DFDS SEAWAYS

RELEVANT REPRESENTATION ON THE PROPOSED IMMINGHAM EASTERN Ro-Ro TERMINAL

PINS REFERENCE TR030007

Image: ABP Environmental Statement: Volume 3 Navigational Simulation Study – Part 1, P48 [APP-90]

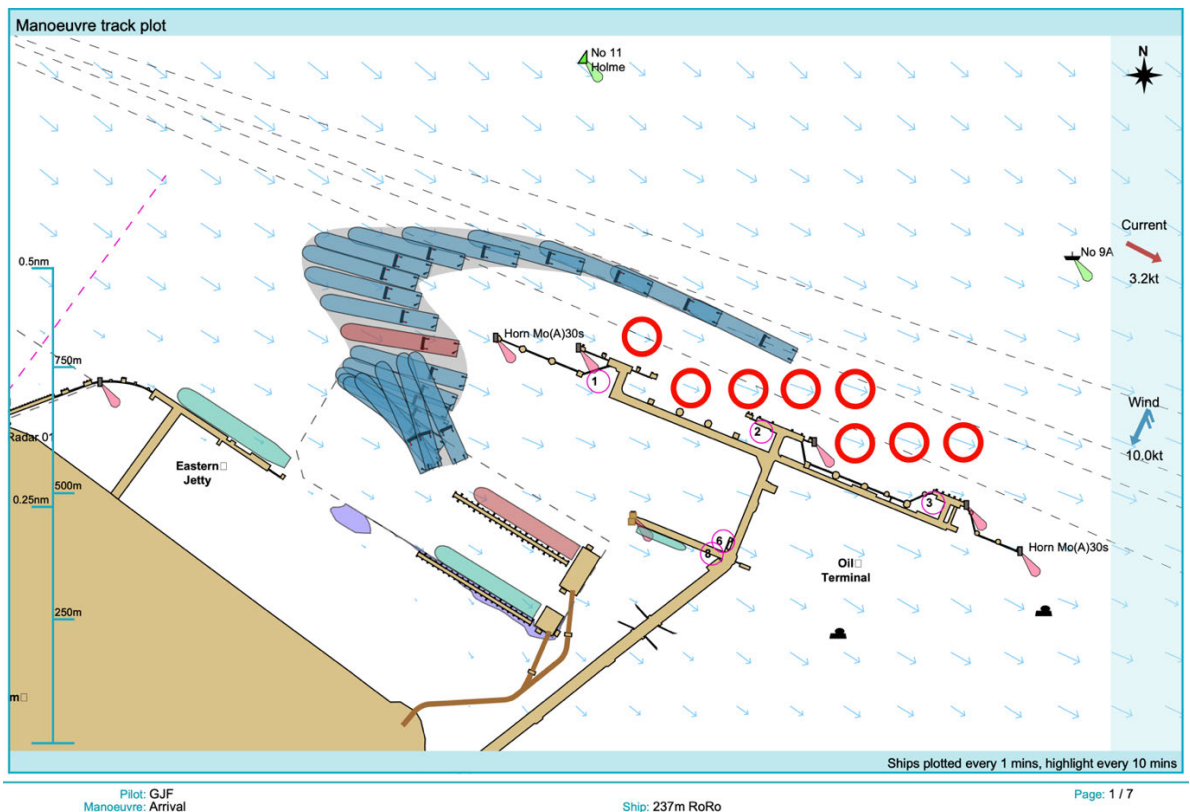
- 3.24 The tide has been a major contributory factor in a number of serious incidents in the IOT and Immingham Bellmouth areas as previously documented.
- 3.25 However upon consulting the simulation reports [APP-90, APP-091] the professional mariners at DFDS were concerned that the direction of the tidal flow as indicated on the simulation imagery were not consistent with this. In the simulations the tidal flow indicated shows the tide running largely parallel to the berth both on flood and ebb tides.
- 3.26 In Simulation Report 1 [APP-90 p48] the diagram clearly shows the ebb tide running parallel to the IOT (tidal arrows circled in red for clarity):

Image: ABP Environmental Statement: Volume 3 Navigational Simulation Study – Part 1, P146 [APP-90]

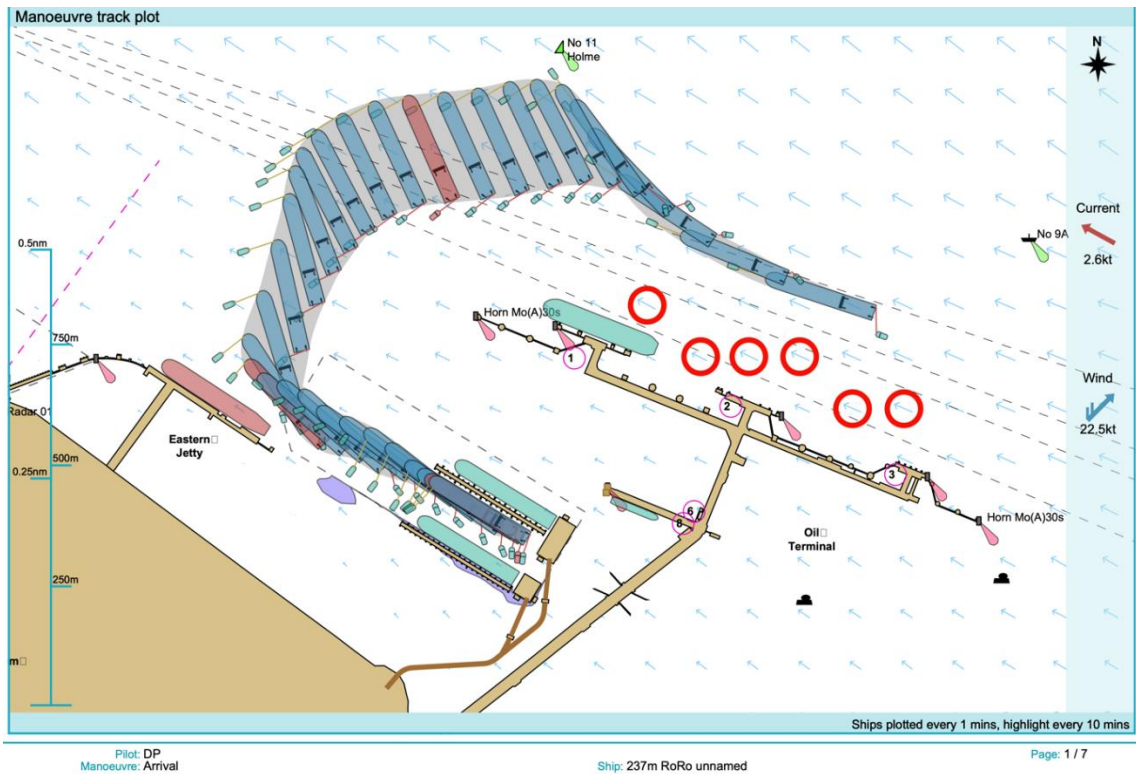
- 3.27 The depiction of the flood tide [APP-90 p146] also indicates a flood tide that acts parallel to the berth (circles again added):

3.28 This is clearly not the case and a point made in various MAIB accident investigation reports, HES documentation and established procedures. Indeed in their own Pilot Handbook, the Applicant correctly indicates the tidal flow in this area (ebb tide indicated with red arrow) which clearly does not run parallel to the IOT, as shown in this image:
